Title Tip/Tilt Piezo Driver Overview		LIGO Project California Institute of Technology Massachusetts Institute of Technology		LIGO	
Size: C	DCC Number: D060287	SCH / PCB Revision: A1	Engineer: R. Abbott	Date: 10/20/2006	Time: 12:08:52 PM
File: C:\Rich's Files\Mycodefiles\ISCDC_readout\PiezoDriver\drv_overview.SchDoe				Sheet 1 of 5

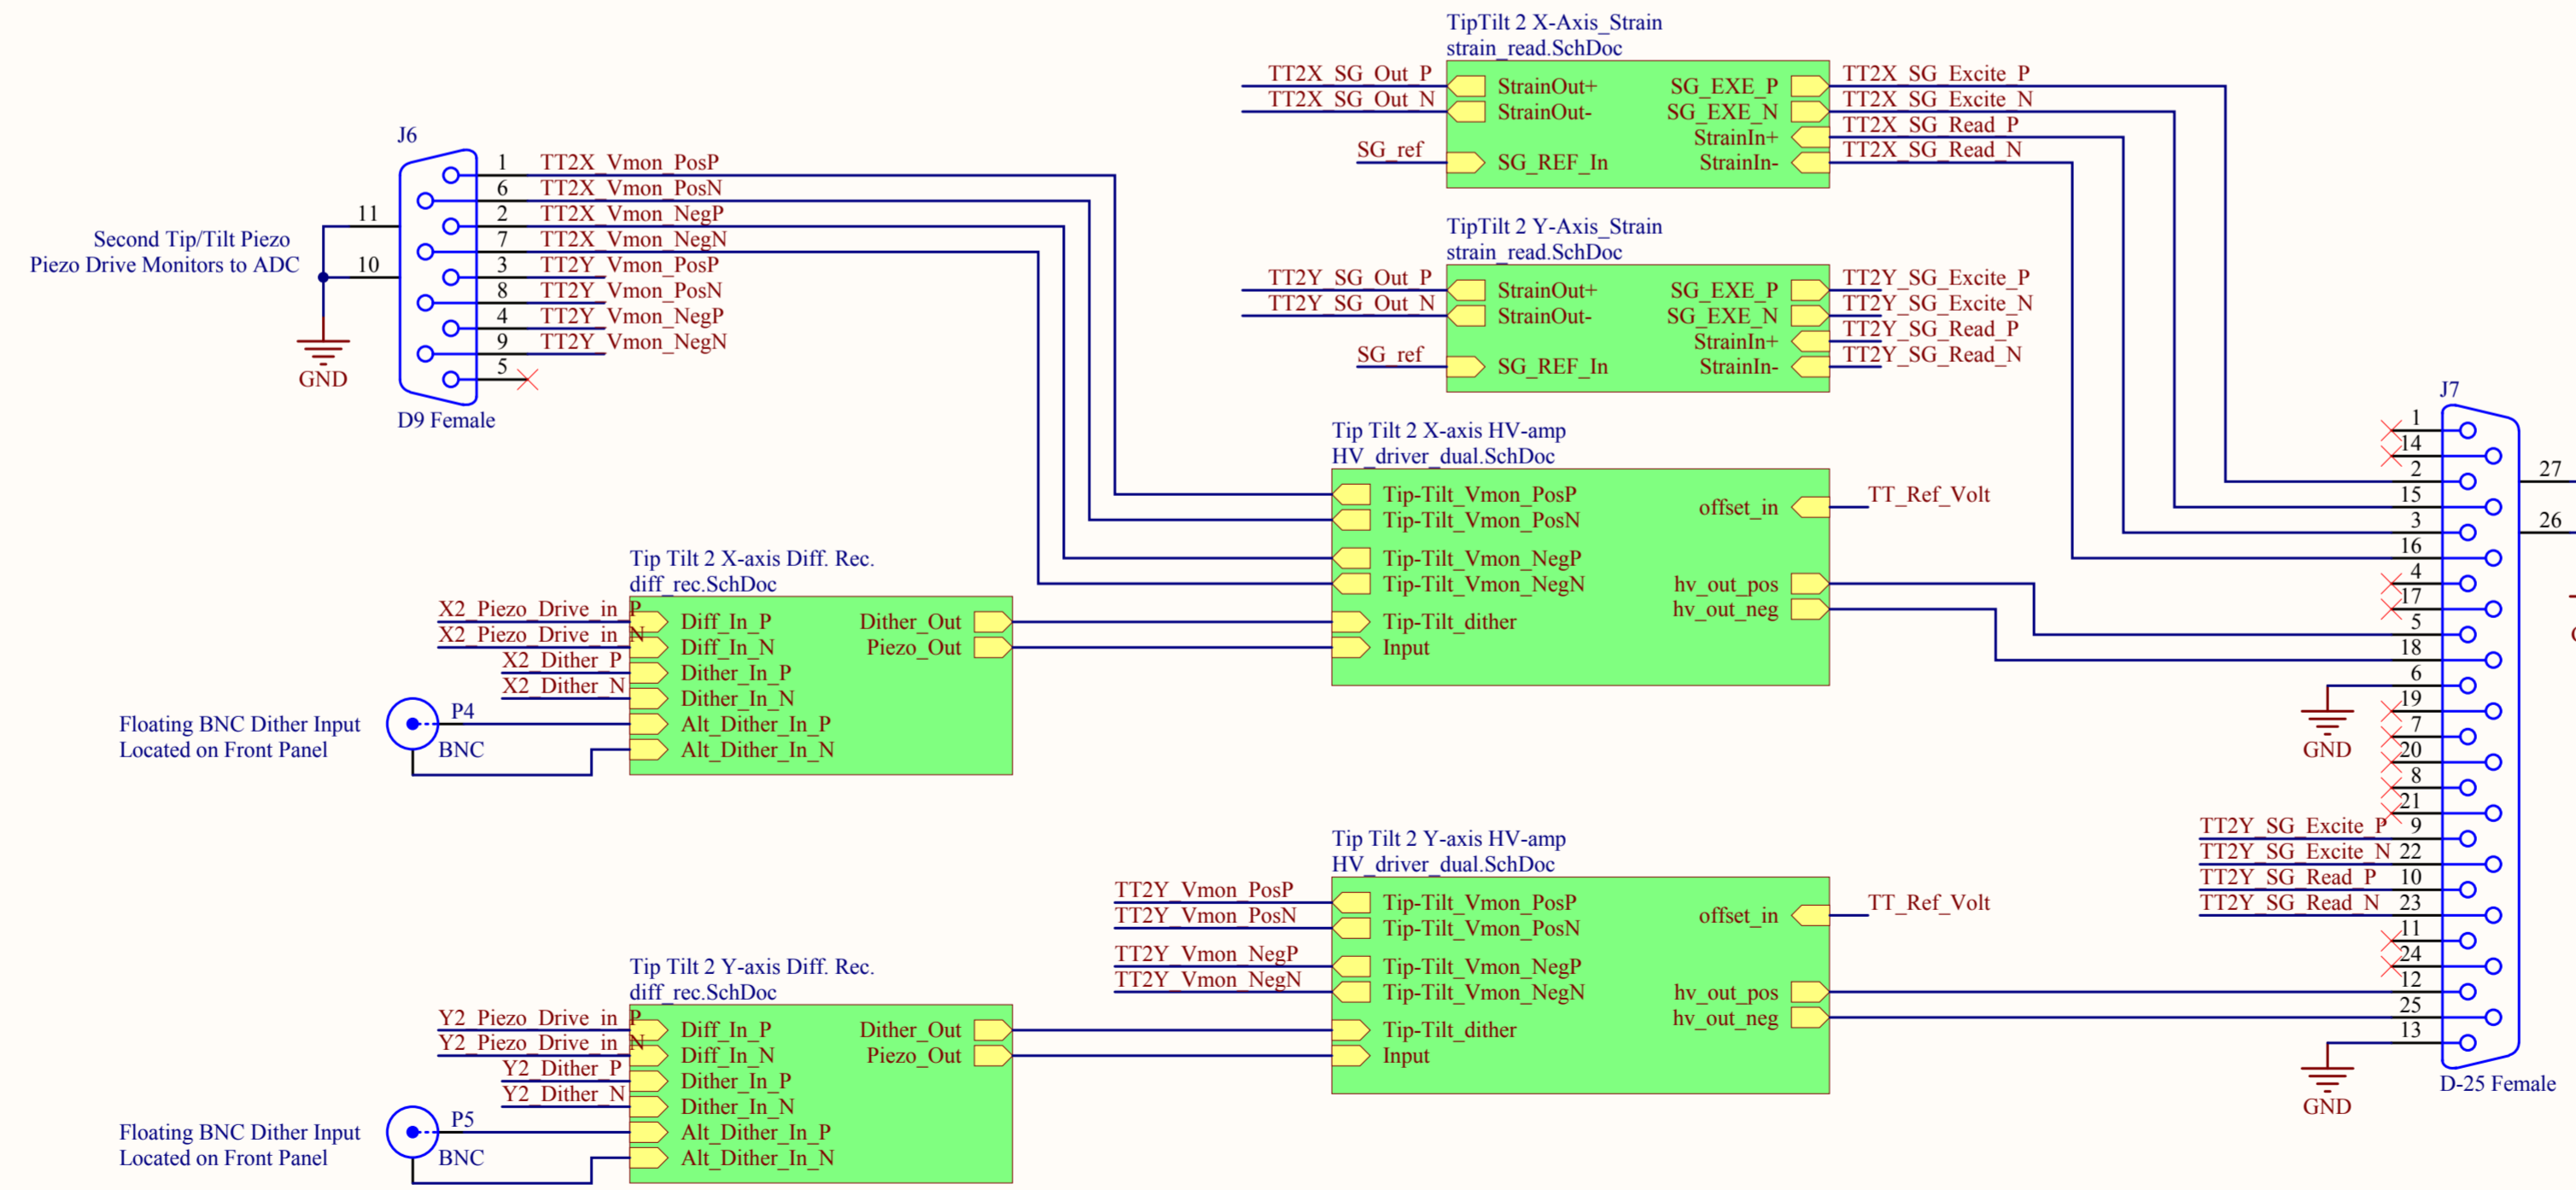
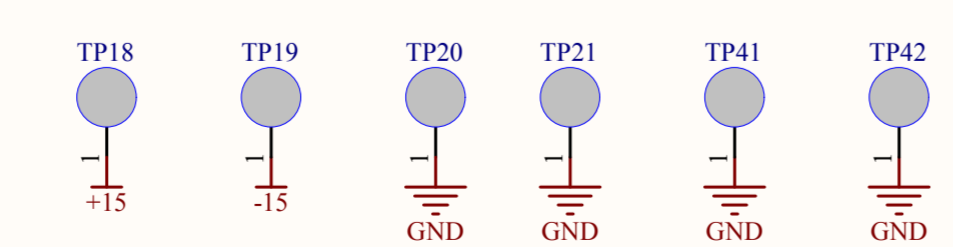
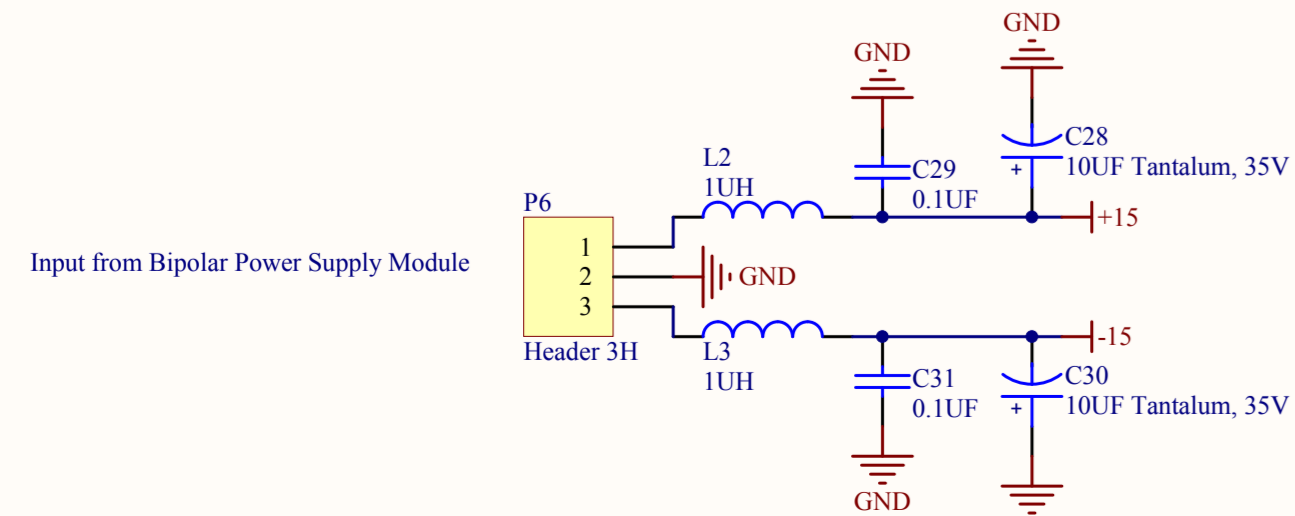
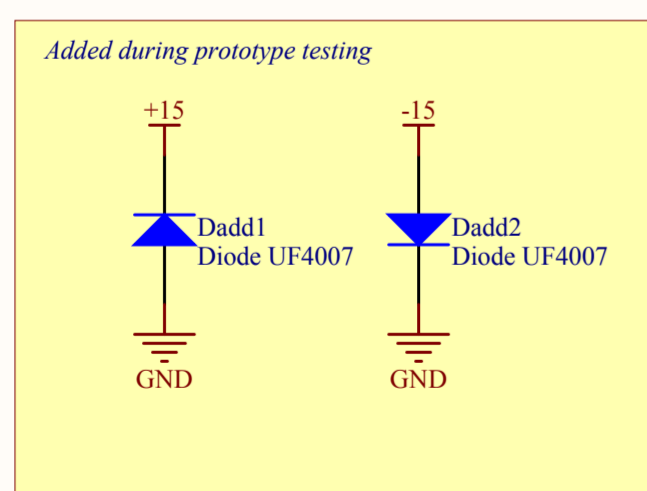
Revision History:
 Rev A was the original prototype.
 Rev A1 incorporates the following changes:
 R62 changed from 10K to 1K
 Changed series resistor on all DRV-135 inputs from 909 ohms to 1.05K
 Added reverse biased UF4007 diodes to ground on LV DC power supply inputs
 Added bipolar TVS chips to all dither amplifier outputs to protect from HV transients
